## Request for Revision to Order of Conditions for Lock Pond Road Culvert Replacement (DEP FILE #286-0279)

**Subject: Locks Pond Road Bridge Replacement  
Control of Water Plan  
Shutesbury, Massachusetts  
Pare Project No.: 21139.00**

**LOCKS POND ROAD BRIDGE REPLACEMENT  
CONTROL OF WATER AT LOCKS POND ROAD  
SHUTESBURY, MASSACHUSETTS**

SHEET NO.: 3.0

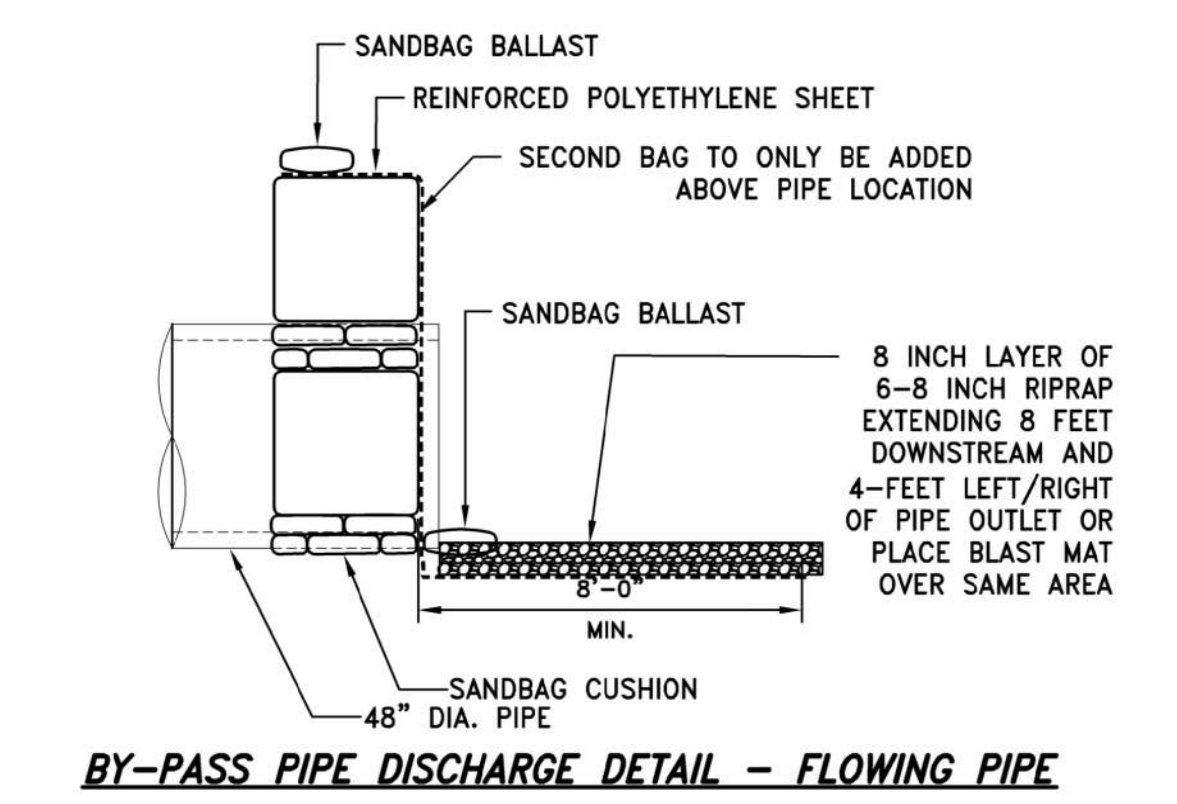
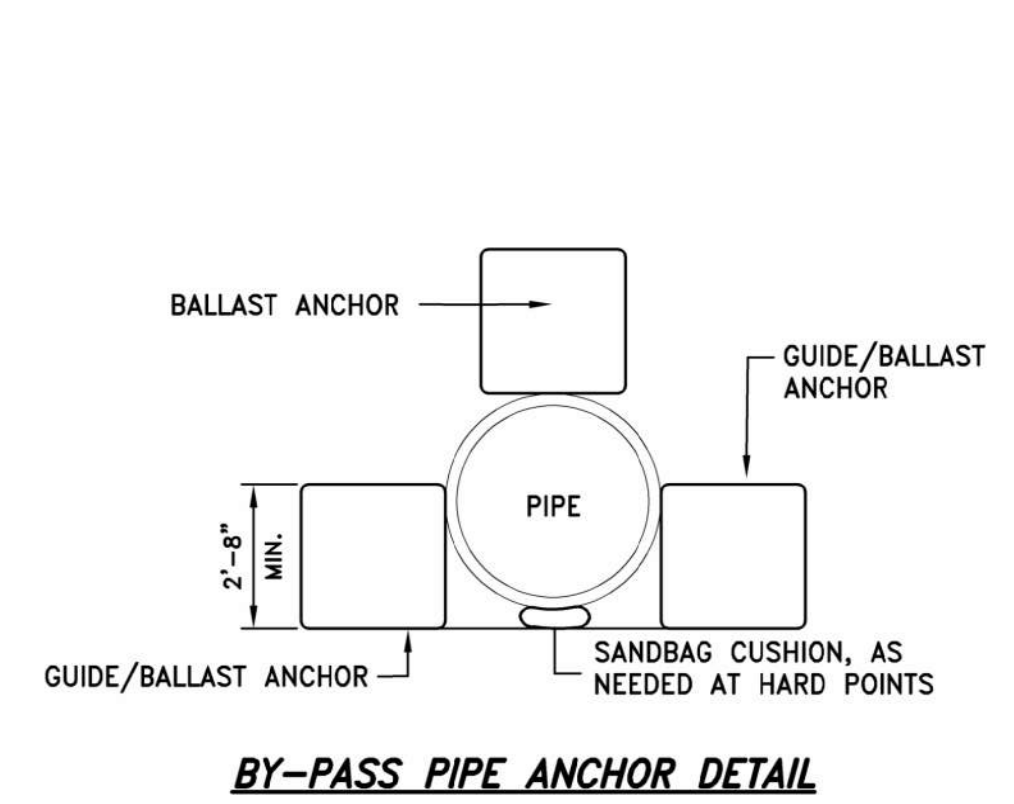
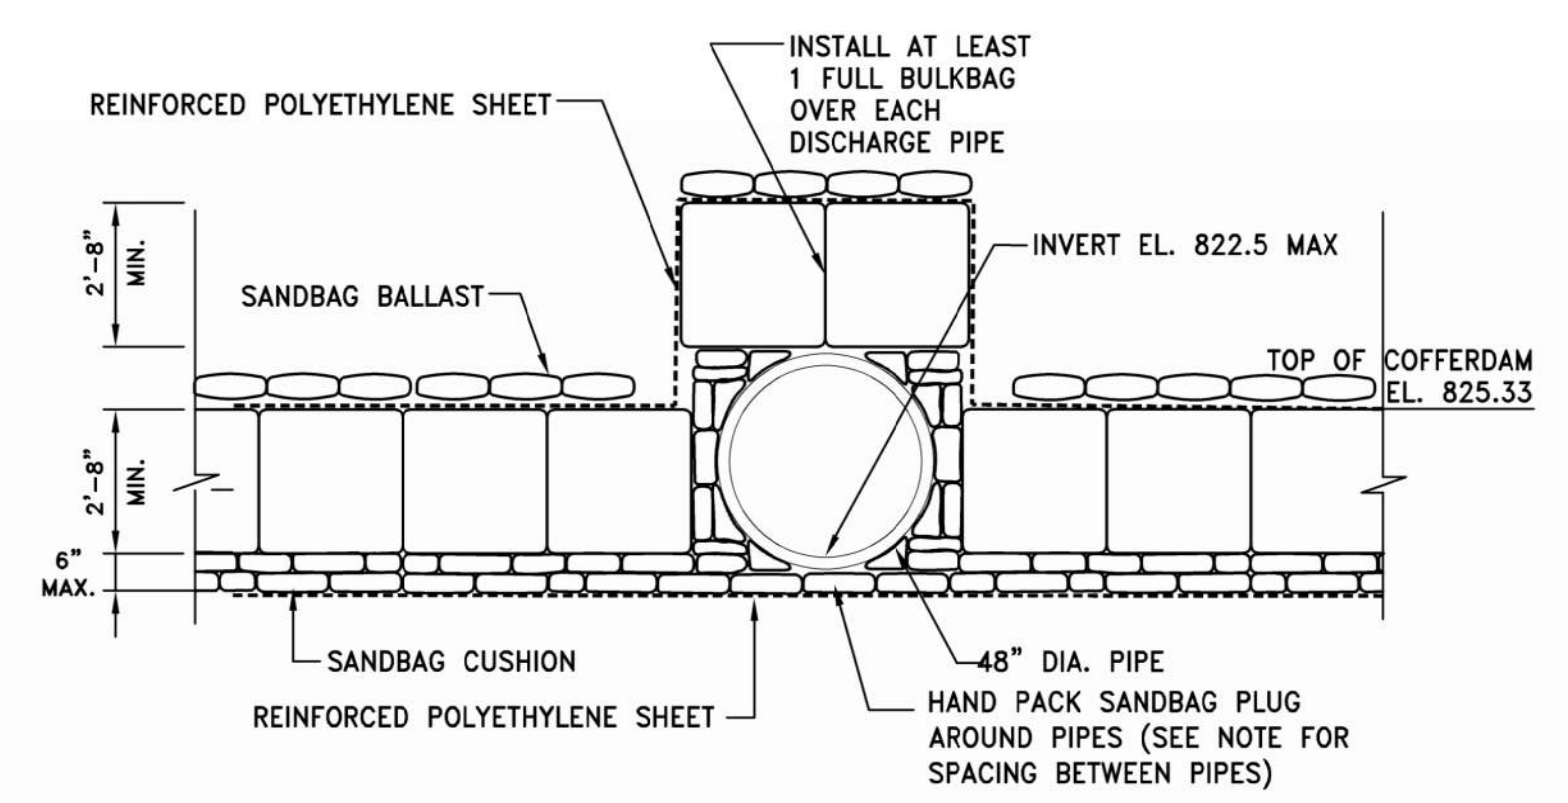
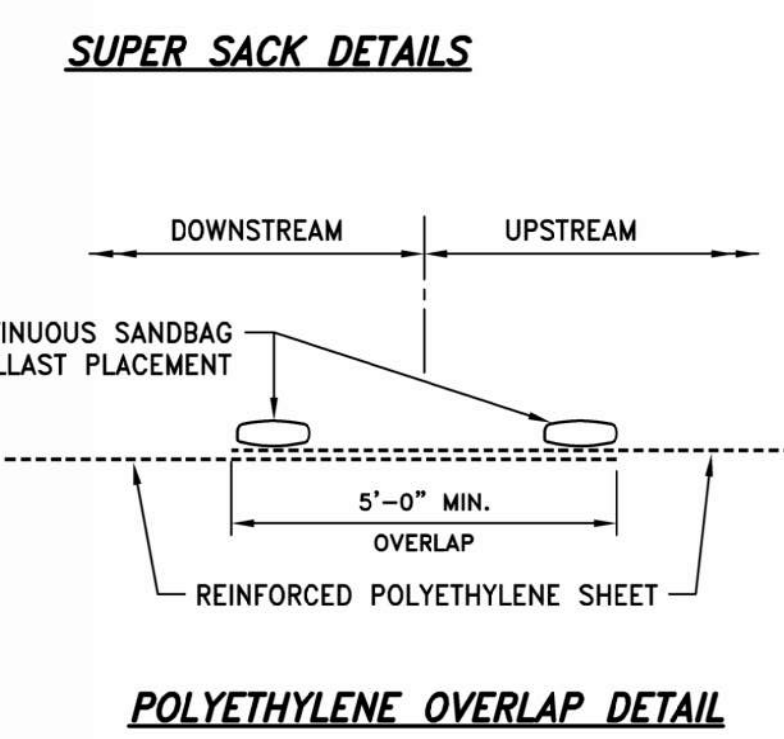
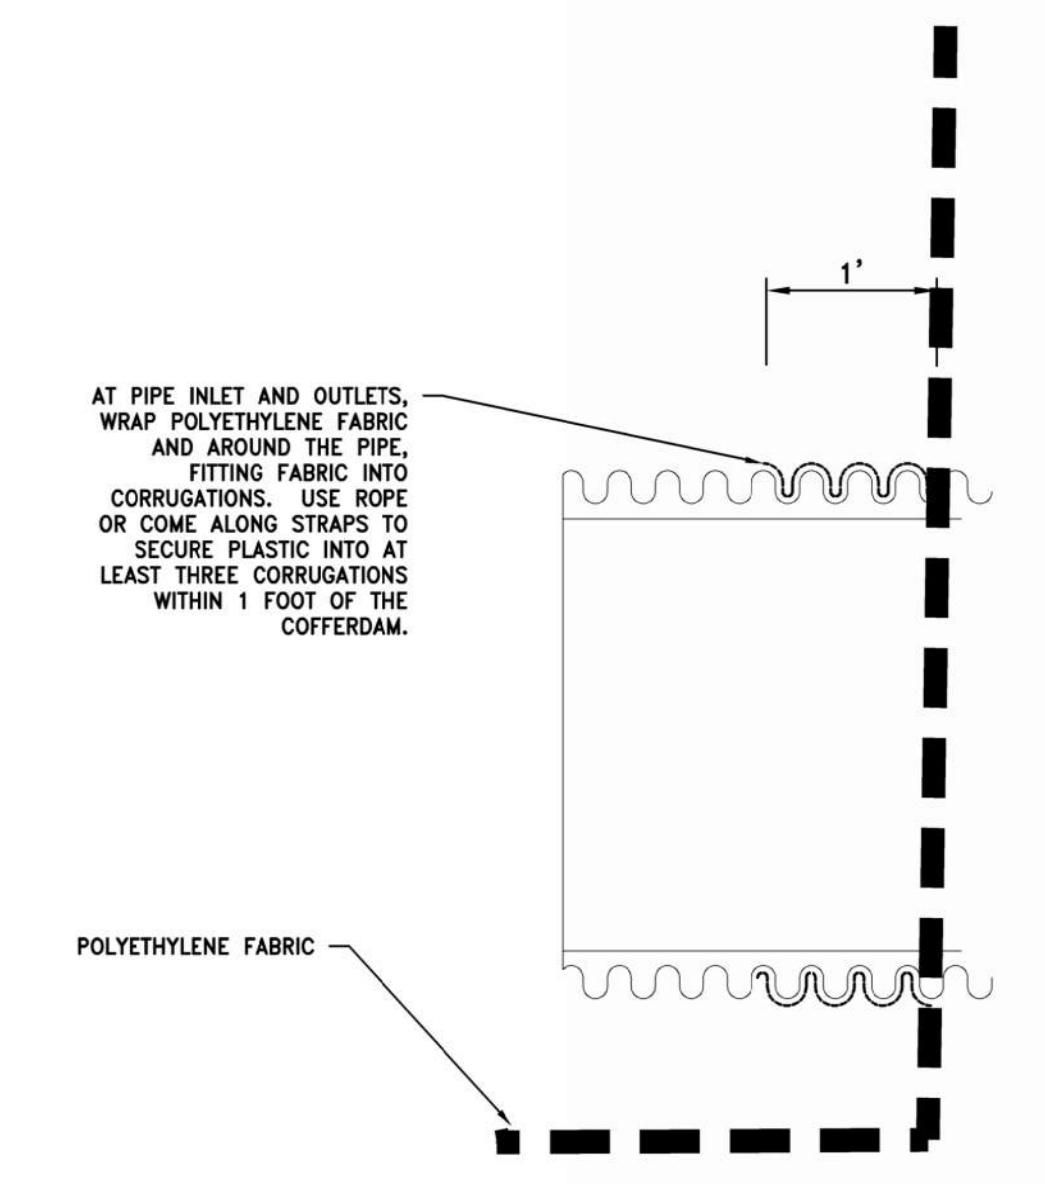
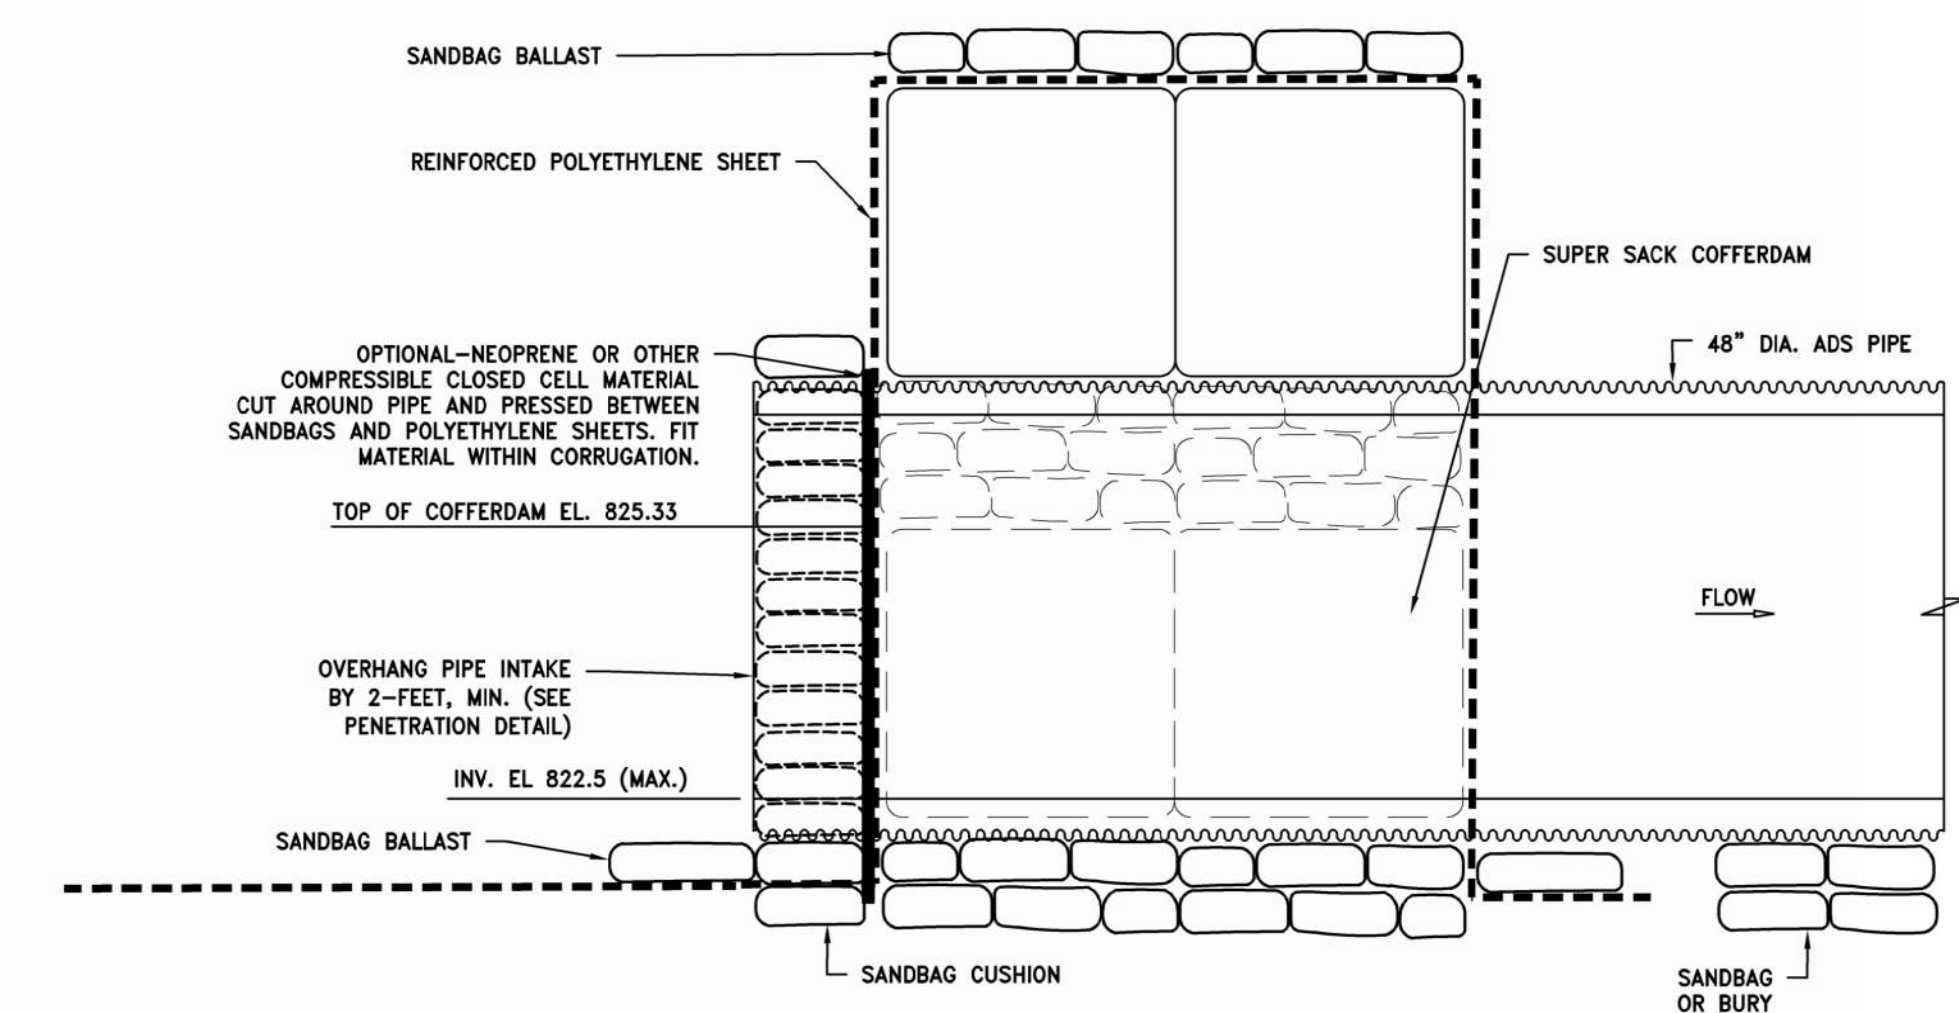
NO.	DATE	DESCRIPTION
1	8-10-2023	REVISED PIPE SIZE AND TOP ELEVATION

- NOTES:**
- TOP OF UPSTREAM COFFERDAM TO BE EL. 825.33.
  - TOP OF DOWNSTREAM COFFERDAM EL. TO BE 824.0.
  - IF NEEDED MAS SHALL STAGGER BAG PLACEMENT SO THAT VERTICAL JOINTS BETWEEN BAGS DO NOT ALIGN.
  - BAG CONFIGURATION C-1 SHALL ONLY BE USED TO ISOLATE THE SPECIFIC WORK AREAS WITHIN THE UPSTREAM AND DOWNSTREAM COFFERDAM LIMITS.
  - IN THE EVENT OF AN OVERTOPPING EVENT A SINGLE BAG AS SHOWN IN A-1 OR A-2 CONFIGURATIONS MAY BE INSUFFICIENT TO RESIST CHANNEL FLOWS. TO INCREASE THE CHANCES OF THE COFFERDAM REMAINING IN PLACE A SECOND ROW OF BAGS CAN BE ADDED BEHIND THE COFFERDAM. A SECOND ROW SHOULD BE OVERLAPPED WITH POLYETHYLENE SHEETING, AS SHOWN IN THE BY-PASS PIPE INLET SECTION DETAIL.
